**CLASS 3 SITE PLAN REVIEW /CLASS 2 ADJUSTMENT CASE NO.: SPR-ADJ22-31**

**REQUEST:** A consolidated application containing a Class 3 Site Plan Review to construct a new 5,418-square-foot overhead fuel canopy with 14 fueling positions, a 179-square-foot cashiers kiosk, and associated site improvements such as landscaping and vehicle parking. The application includes a Class 2 Adjustment request to reduce the minimum development site landscaping standard from 15 to 3.2 percent.

<b>IN THE MATTER OF APPROVAL OF</b>	<b>) FINDINGS &amp; ORDER</b>
<b>CLASS 3 SITE PLAN REVIEW AND</b>	<b>)</b>
<b>CLASS 2 ADJUSTMENT</b>	<b>)</b>
<b>CASE NO. SPR-ADJ22-31</b>	<b>)</b>
<b>2980 RIVER ROAD N - 97303</b>	<b>) JULY 18, 2022</b>

## SEC. 15 AND SEC. 10, TWP. 7 S., RGE. 3 W., W.M. PRELIMINARY SITE PLAN

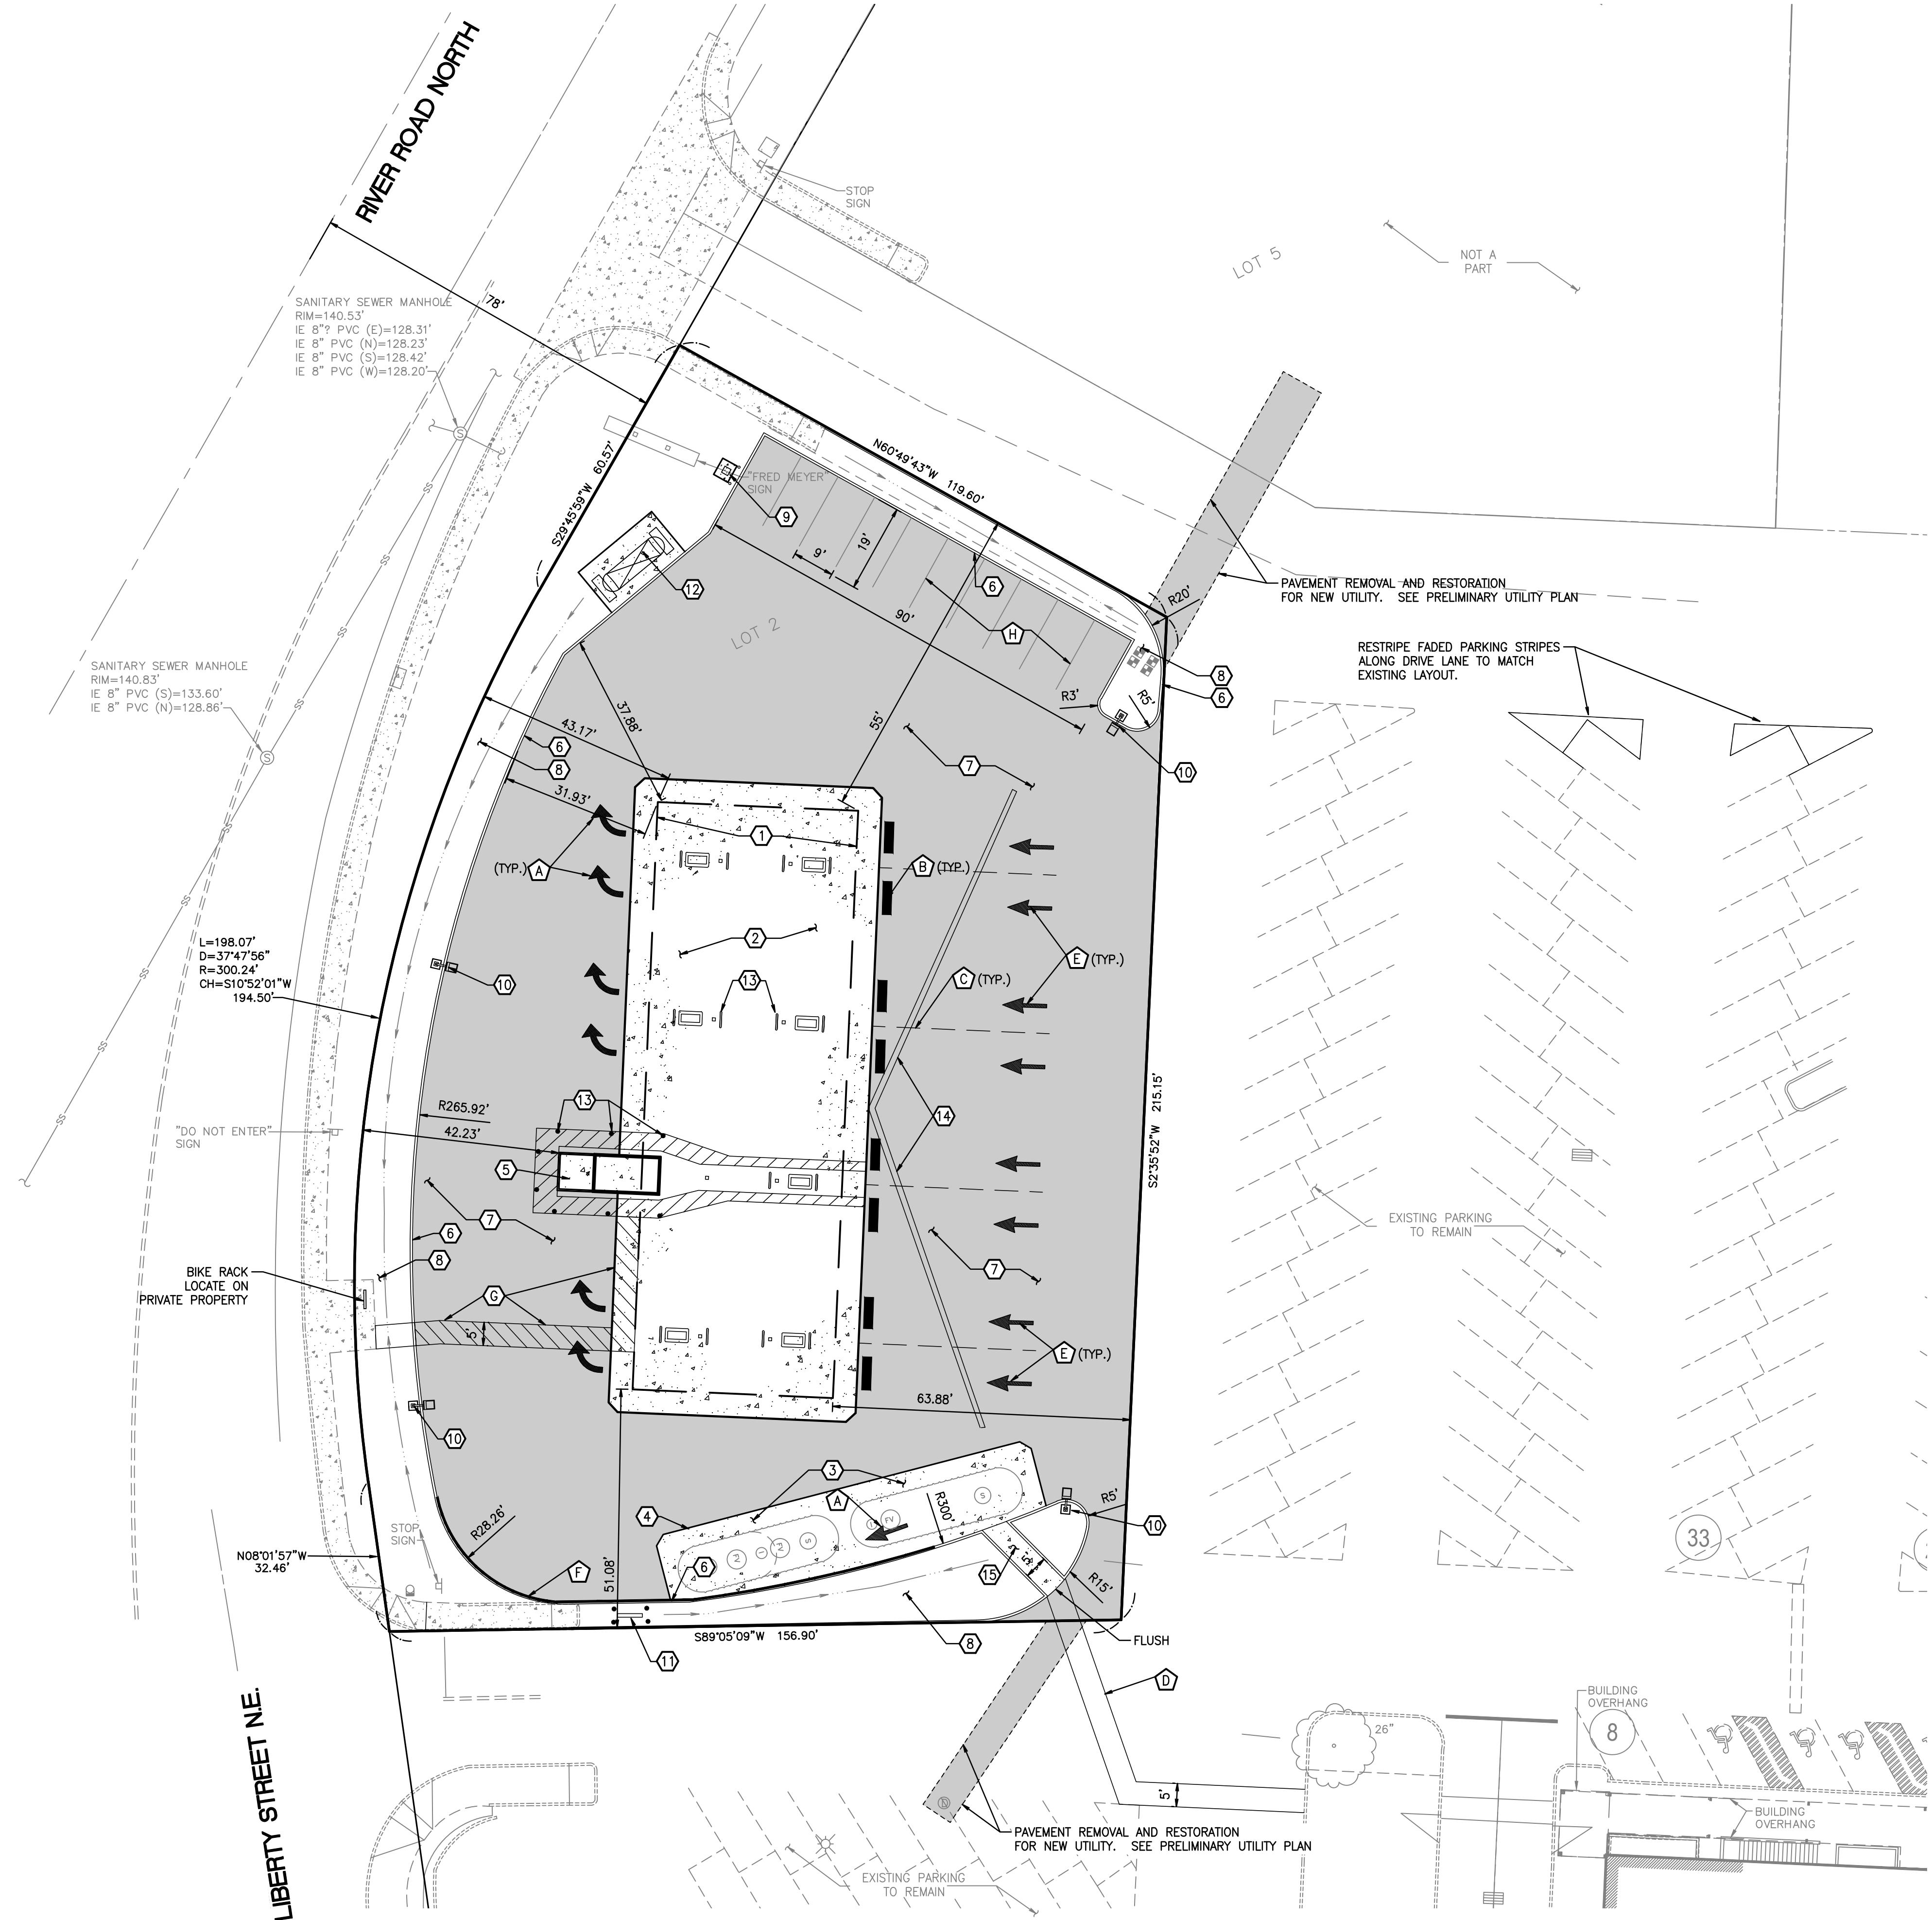
**Finding:** The subject property has frontage on River Road NE and Liberty Street NE where the two streets meet. The existing conditions of River Road N and Liberty Street NE do not meet current standards for their classification of street per the *Salem Transportation System Plan*. In 1998, 48-feet from centerline of River Road N was dedicated along the frontage of the subject property per plat no. 98-4S. The plat also shows a 34-foot half width from centerline right-of-way along Liberty Street NE. No additional right-of-way on the development side of the street is required.

**Finding:** The existing driveway approaches and curb returns on River Road N do not meet current Public Works Design Standards for commercial approaches, the applicant shall replace the nonconforming driveway approaches. As conditioned, the driveway access onto River Road N and Liberty Street NE will provide for safe turning movements into and out of the property.

**Finding:** The Public Works Department has reviewed the applicant's preliminary plan for this site. The water, sewer, and storm infrastructure are available within surrounding streets/areas and are adequate to serve the proposed development. The applicant's preliminary site plan shows new water services crossing adjacent private property. The applicant is required to obtain easements for new City services on adjacent private property or demonstrate that an easement exists.

The subject property is approximately 0.89 acres (38,695 square feet) in size. The applicant indicates that the proposal equally or better meets the applicable standard because if the landscape standard is applied only to the lot being developed. Approximately 6,299 square feet, or 16.3 percent, of new landscape area provided on Lot 2, exceeding the minimum 15 percent standard. In addition, the new trees and shrubs to be planted are in an area that currently has no landscaping. These new landscape materials will help to enhance not just the subject property, but the surrounding area and adjacent lots. Staff finds that the requested adjustment equally or better meets the intent of the standard.

- a. Restripe the existing shared northbound left/through/right-turn and merge lane on Liberty Street NE at Riviera Drive NE to provide an exclusive northbound right-turn lane in conjunction with site development.
- b. Above-ground utilities, monuments, fencing, and vegetation should be appropriately located and maintained at the existing site access locations and along the River Road N site frontage to preserve adequate intersection sight lines per City of Salem standards.

**Condition 2:** Replace nonconforming driveway approaches and curb returns on River Road N and Liberty Street NE to meet current Public Works Design Standards for commercial development.

**Condition 3:** Provide public utility easements for City infrastructure on private property pursuant to PWDS.

**Condition 5:** The adjusted landscape standard for the development site, as approved in this zoning adjustment, shall only apply to the specific development proposal shown in the attached site plan. Any future development occurring on the development site, beyond what is shown in the attached site plan, shall conform to all applicable development requirements, unless adjusted through a future land use action.

SEC. 15 AND SEC. 10, TWP. 7 S., RGE. 3 W., W.M.  
PRELIMINARY UTILITY PLAN

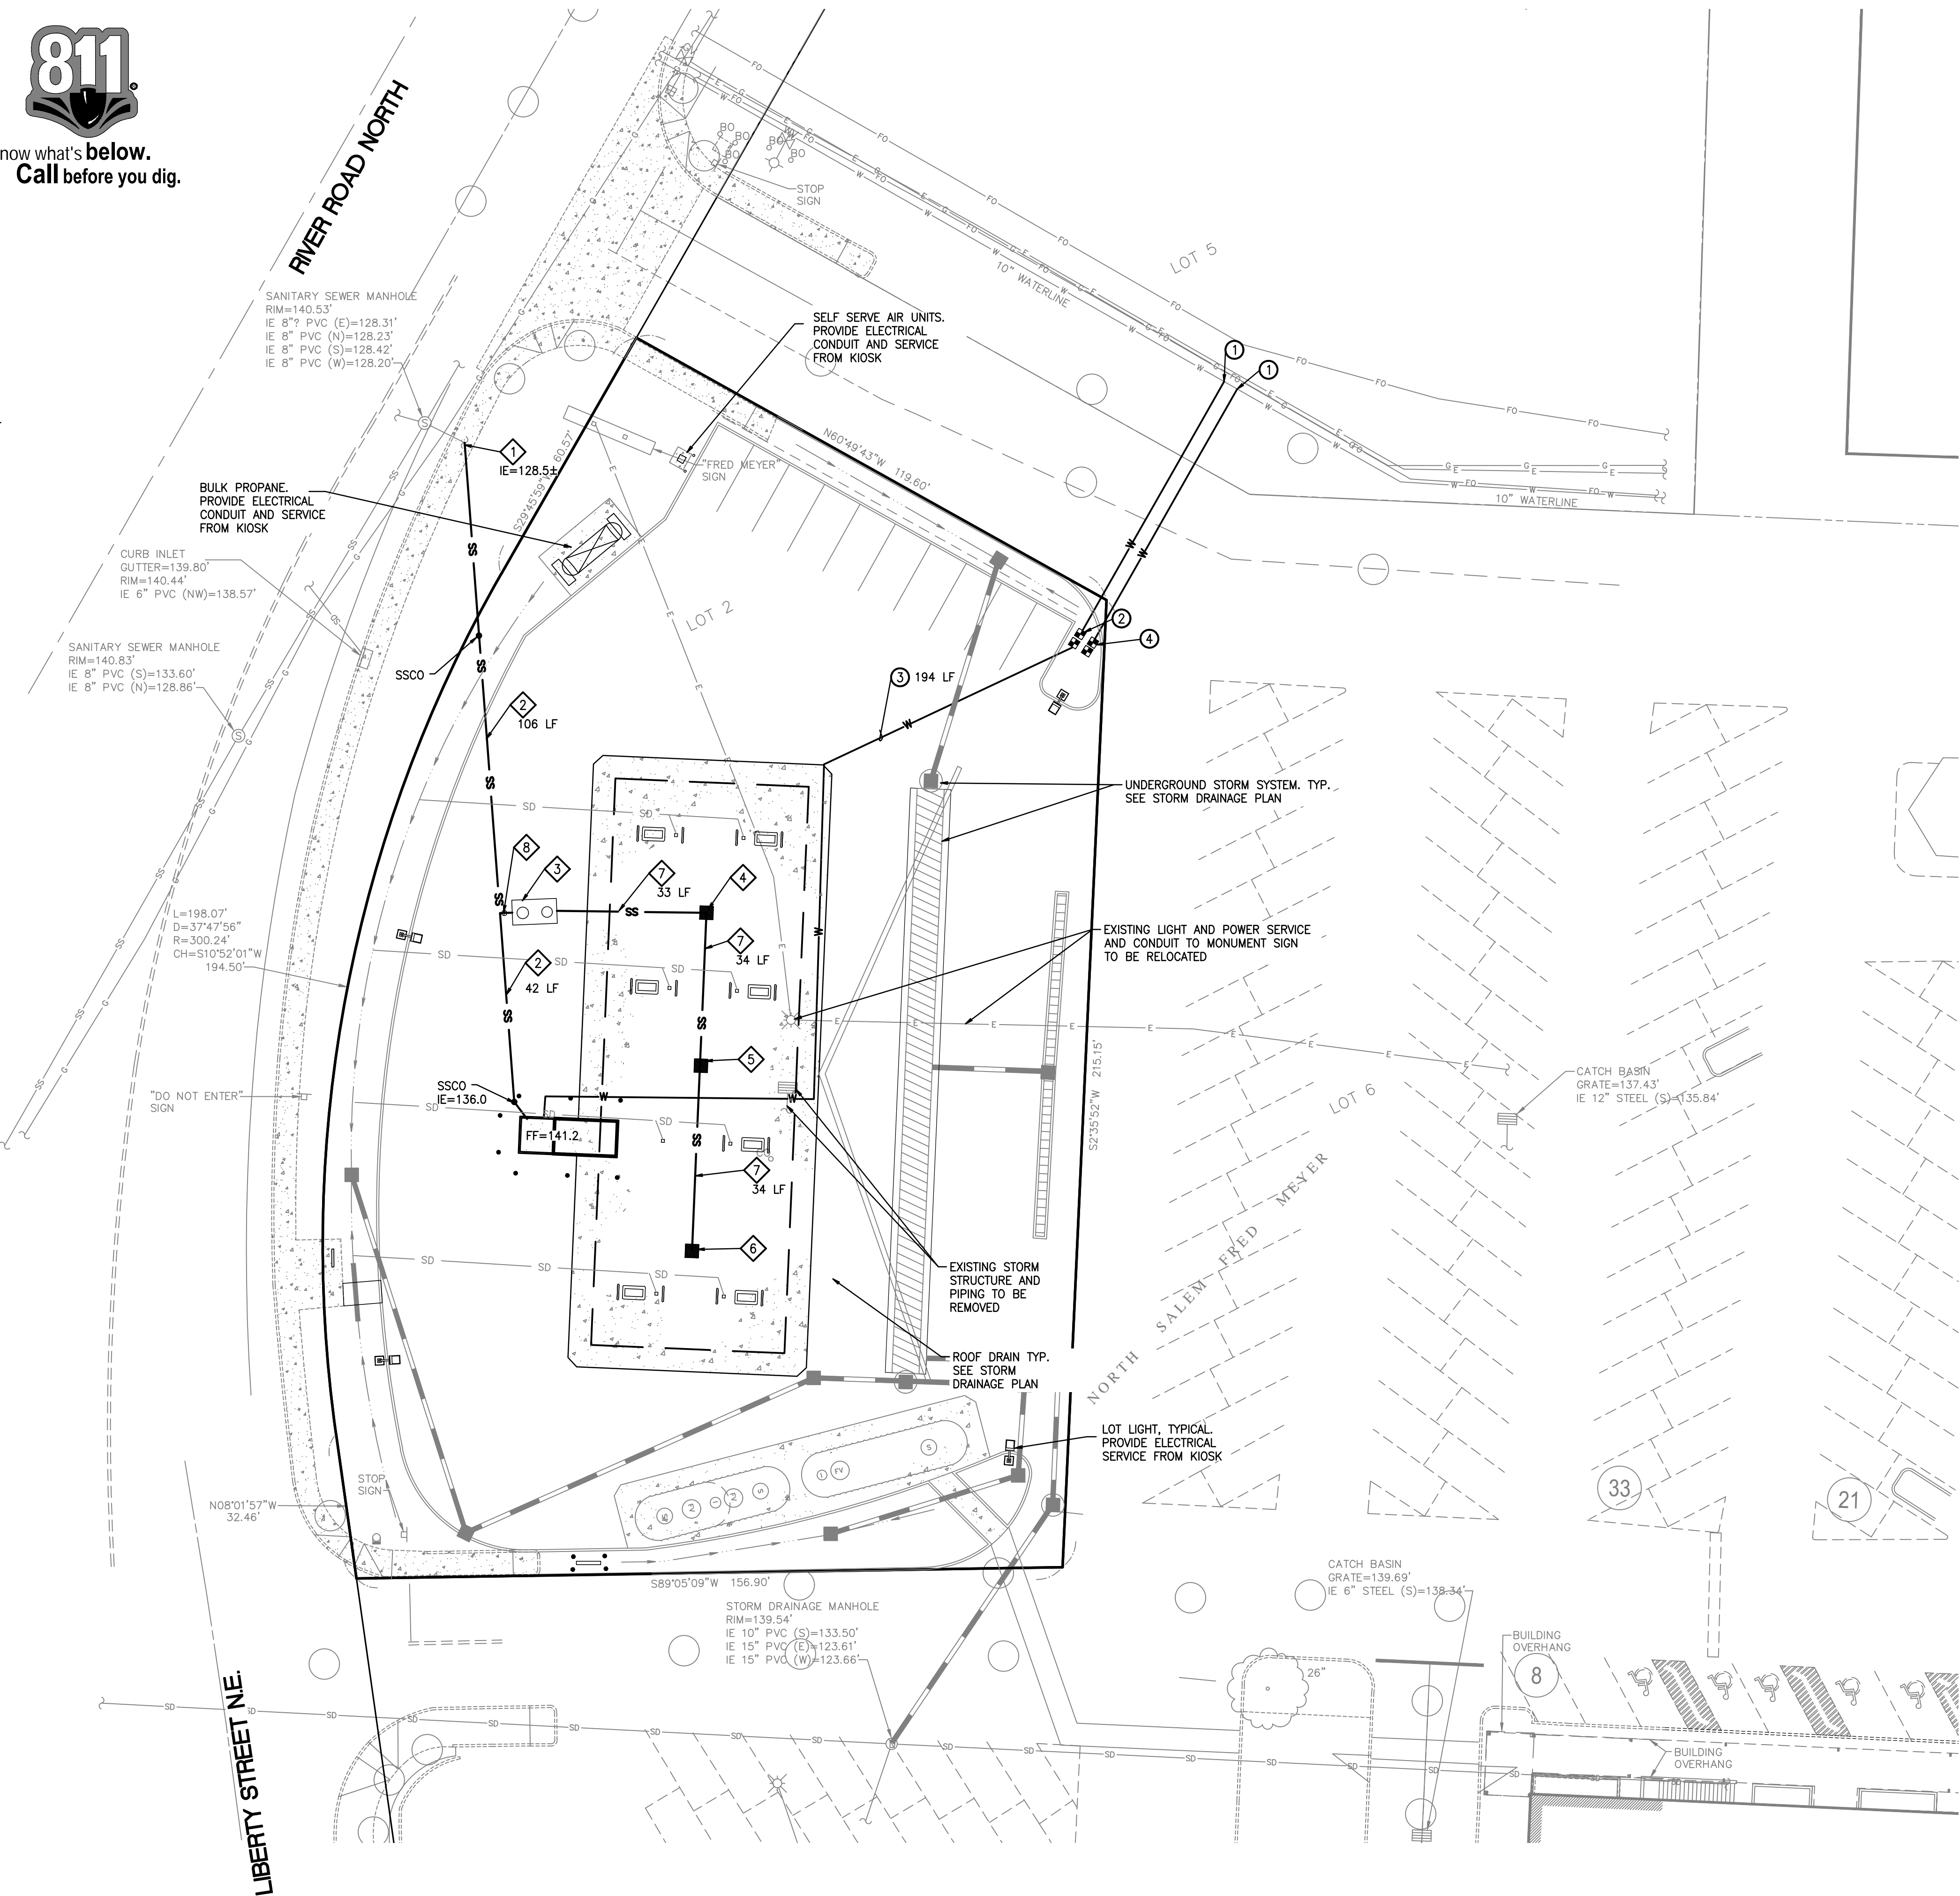
**Finding—**The Public Works Department has reviewed the applicant's preliminary plan for this site. The water, sewer, and storm infrastructure are available within surrounding streets/areas and are adequate to serve the proposed development. The applicants

preliminary site plan shows new water services crossing adjacent private property. The applicant is required to obtain easements for new City services on adjacent private property or demonstrate that an easement exists.

**Condition:** Provide public utility easements for City infrastructure on private property pursuant to PWDS.
